DART AEROSPACE LTD		Work Order:	93996
Description: Crosstube Assembly (205/212/412 High Fwd)		Part Number:	D212-664-141
Inspection Dwg: D212-664-141 Rev: D		Page 1 of 2

DRAWING NO. D212-664-141	TITLE XTUBE ASSY (205/212/412 HI FWD)	REV. D	DART AEROSPACE LTD ENGINEERING ORDER		D.E.O. NO. D212-664-141-D-1	SHEET NO. SHEET 1 OF 2	SCALE NTS
DRAWN	CHECKED	MFG. APPR.	APPROVED	DE APPR.			
DATE 11.04.07	DATE 11.04.11	DATE 11.04.12	DATE 11/04/12	DATE 11.04.12

**D212-664-141/-141B
ASSEMBLY DETAIL**

DRAWING NO. D212-664-141	TITLE CROSSTUBE ASS'Y (205 HI FWD)	REV. D	DART AEROSPACE LTD ENGINEERING ORDER		D.E.O. NO. D212-664-141-D-2	SHEET NO. SHEET 1 OF 1	SCALE NTS
DRAWN <i>UP</i>	CHECKED <i>ASS</i>	MFG. APPR. <i>PS</i>	APPROVED <i>MP</i>		DE APPR. <i>TH</i>		
DATE 11.07.15	DATE 11.07.20	DATE 11.07.21	DATE 11/07/21		DATE 11.07.21

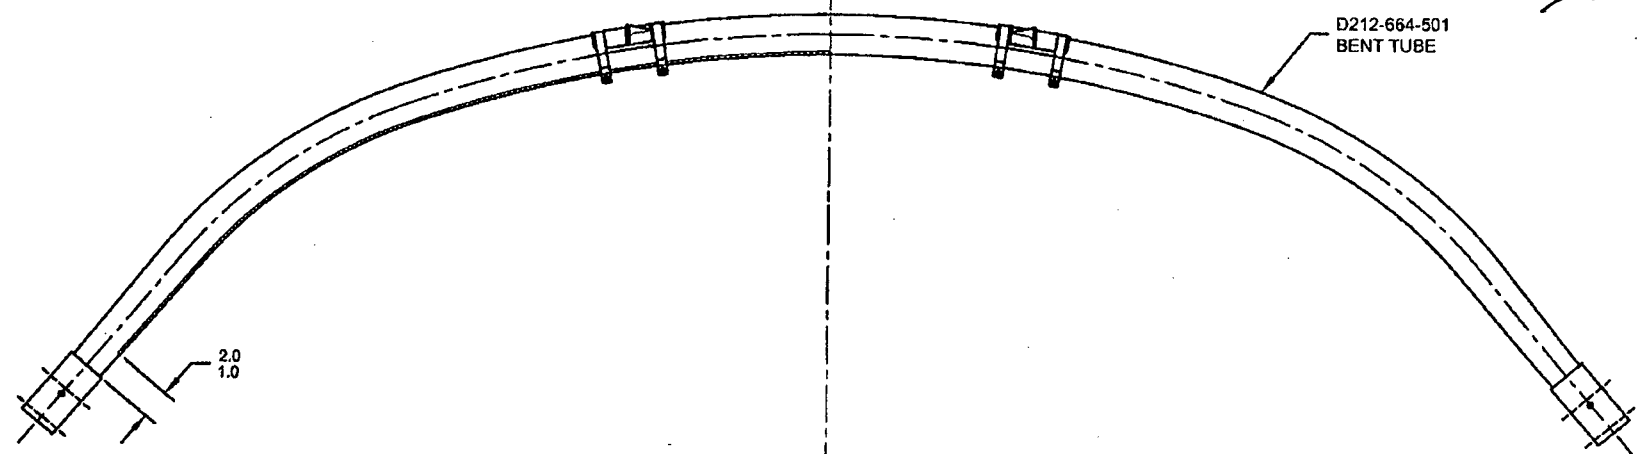
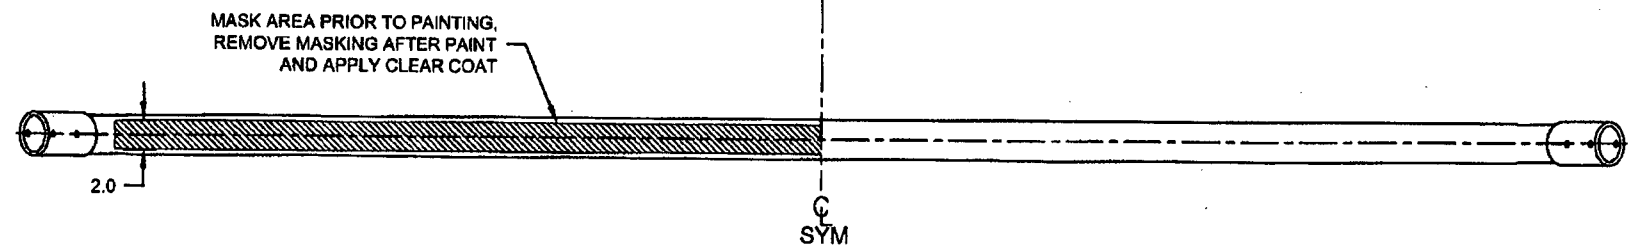
ADD AN INSPECTION WINDOW TO UNDERSIDE OF CROSSTUBE.

NOTES 2 OF SHEET 1 IS AMENDED AS FOLLOWS:

- 2) FINISH: CHEMICAL CONVERSION COAT PER DART QSI 005 4.1
PRIME INSIDE AND OUTSIDE PER DART QSI 005 4.2
MASK UNDERSIDE OF CROSSTUBE AS SHOWN (HATCHED AREA) AND
PAINT OUTSIDE PER DART QSI 005 4.2
REMOVE MASKING AND APPLY CLEAR COAT

- 2) FINISH: CHEMICAL CONVERSION COAT PER DART QSI 005 4.1
PRIME INSIDE AND OUTSIDE PER DART QSI 005 4.2
PAINT OUTSIDE PER DART QSI 005 4.2
